# Technical Service Bulletin

<b>Subject:</b>  <b>A/C BLOWS WARM AIR DUE TO REFRIGERANT LEAK FROM CONDENSER</b>	<b>Bulletin No.:</b> 07-001/19
	<b>Last Issued:</b> 01/11/2019

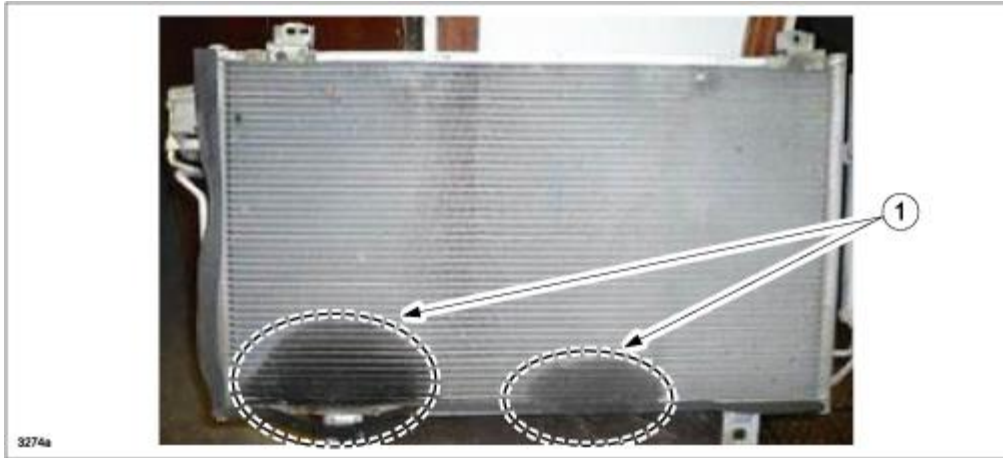
Some customers may complain about warm air from the climate control vents when the air conditioner is ON. This may be caused by condenser corrosion, causing a refrigerant leak.

1. Verify the customer concern.
2. Visually inspect the condenser for A/C refrigerant leak.
  - Is there a visible trace of A/C refrigerant leaking at location (1)?

- Yes - Go to step 4.
  - No - Go to step 3.
3. Use a dealer supplied UV leak detection tool. Is there a trace of fluorescent liquid at location (1)?

The manufacturer of the condenser has been changed and the configuration of the condenser tube has been improved.
